City of El Paso – City Plan Commission Staff Report

Case No: SUSU11-00120 Desert Springs Unit One
Application Type: Major Combination
CPC Hearing Date: January 26, 2012

ATTACHMENT 3

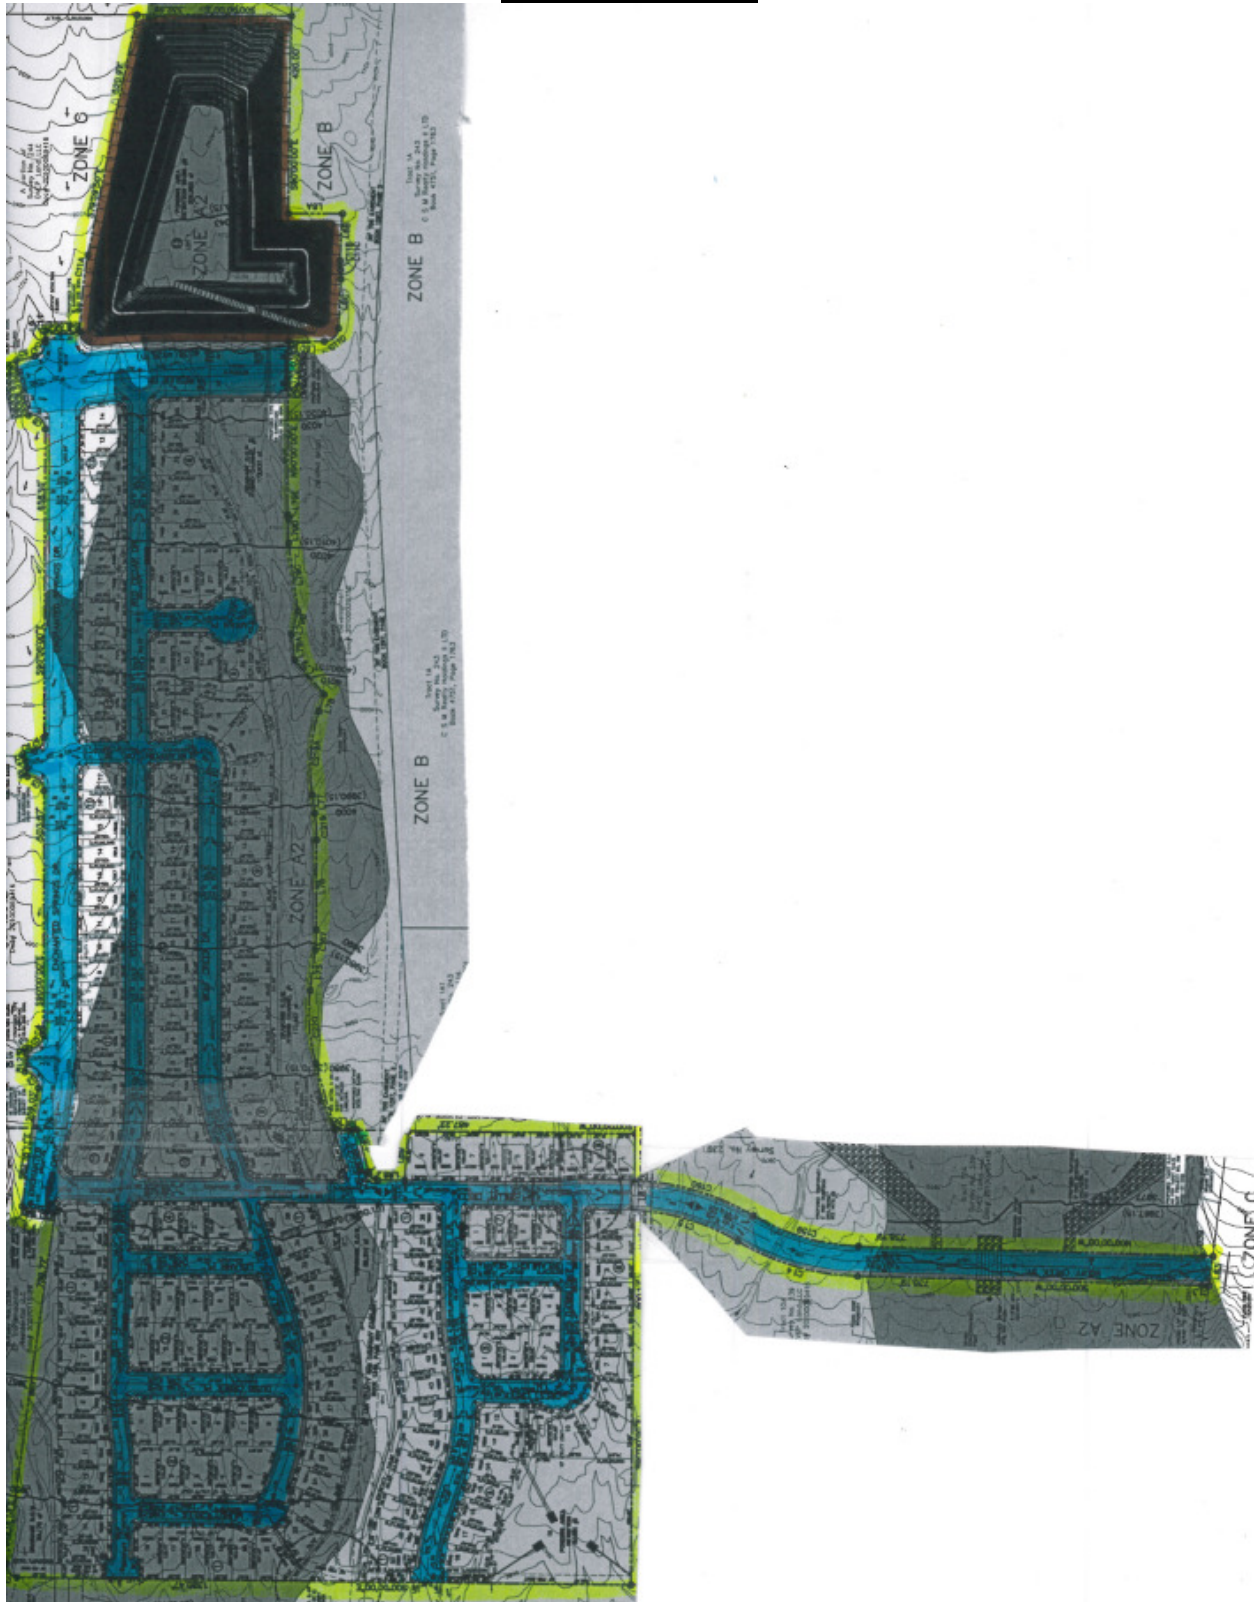
1. The ponding area proposed at Lot 1, Block 13 shown on the plat lacks several structural features required by the subdivision improvement design standard. Among these are an emergency concrete spillway and an access road. Also, the topography on the plat indicates the detention basin sides will exceed the maximum slope.

2. The subdivider proposes two (2) hybrid channels within Desert Springs Unit 1. The hybrid channels will have concrete lined side slopes and earthen bottoms. Although this hybrid channel cross section does not meet any design standard in the subdivision code, EPWU recognizes that the City of El Paso Engineering Department previously requested the design. The Engineer shall provide enough information to prove the hybrid channels will provide for and protect public health, safety, and general welfare as required by 19.04.030.

3. The plat shows a 30' Lea County Gas Company Easement located within the boundary of the south Drainage Right-Of-Way (proposed Hybrid Channel #1) in Block 1. EPWU and the Developer met on 11/22/10 to discuss the Hybrid Channel and gas company easement. EPWU requested that the Developer design the channel so the high pressure gas company pipeline is relocated beneath the channel service road. The high pressure gas pipeline's current location along the natural channel bottom will potentially interfere with EPWU channel maintenance.

4. Stormwater drainage facilities that are to be maintained by EPWU shall be encompassed within a designated City-owned property or right-of-way. According to Section 19.16.050 of the subdivision code, public storm sewers shall be accessible for inspection and maintenance by the city. We recommend changing the drainage easements (for storm drain pipe) located within residential lots to drainage right-of-ways.

5. The proposed temporary diversion dike/berm shown on the plat east of Bluff Creek Street in Lots 1-3, Block 8 and the accompanying narrowing of Flow Path 40 caused by the dike/berm system will increase runoff velocity downstream of the Bluff Creek Street culverts. The increased velocity may create more erosion and sediment deposition at off-site properties west of the Desert Springs Unit 1 subdivision. The plat does not include enough information to demonstrate how the dike/berm system energy dissipators will mitigate the adverse downstream erosion and sedimentation. According to 19.16.050C (Stormwater Design – Accommodation of Downstream Drainage Areas), subdivision plans must include methods to mitigate adverse downstream drainage conditions created by the new subdivision so this needs to be documented

ATTACHMENT 4

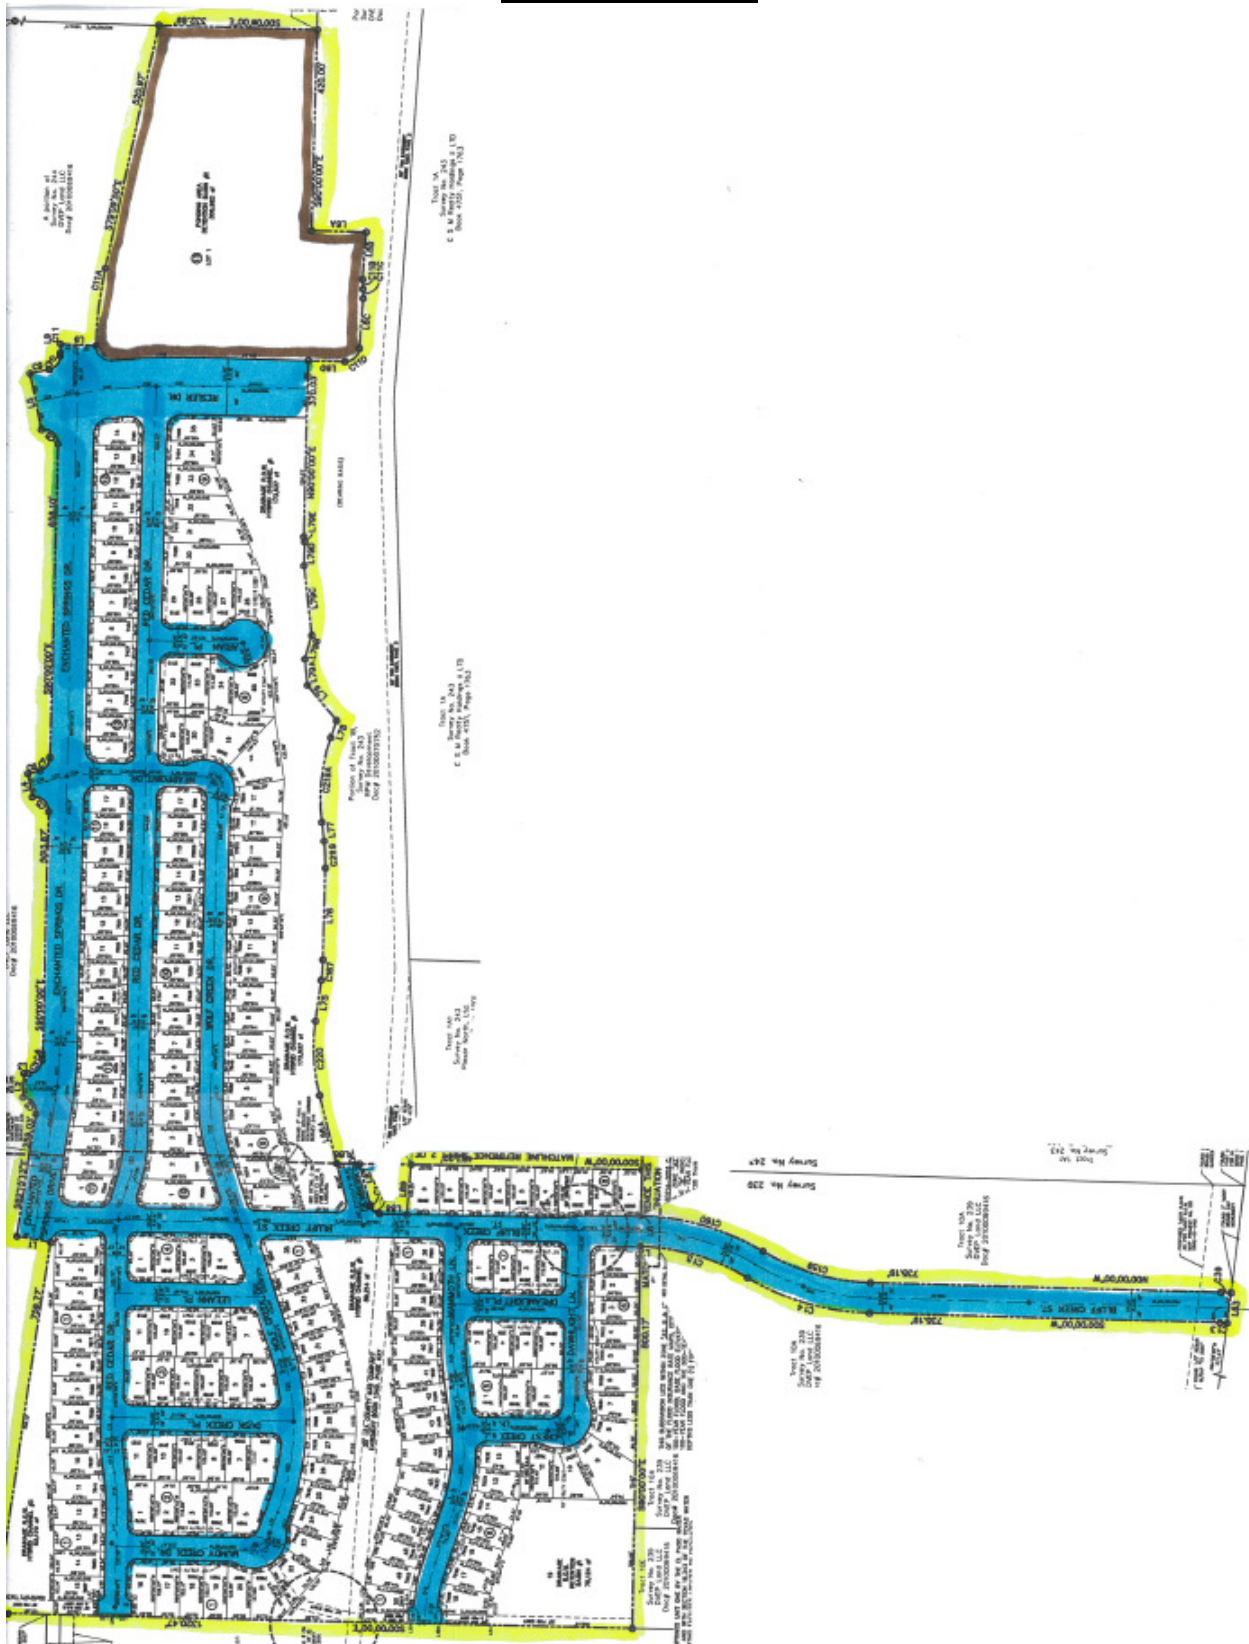
1. Please note that this plat consists of 197 Single-family dwelling lots and does not include a "Park site" however, this is part of the Desert Springs Land study and applicant is dedicating a 1.34-acre "Park" included in "Desert Springs #2 (which is running concurrently with this subdivision) which will accrue 1.05-acres of "Parkland Credits" which will be applied to this development to meet the minimum "Parkland" requirements as follows:

2. Desert Springs #2 shall be recorded prior to or concurrently with this subdivision in order for applicant to accrue said credits and be able to apply them to offset the parkland requirements for this subdivision.
3. The issue with the 30' LEA County Gas Company Easement (Oneok WestTex Transmission, L.P.) has received the Parks & Recreation Department Director affirmative recommendation.
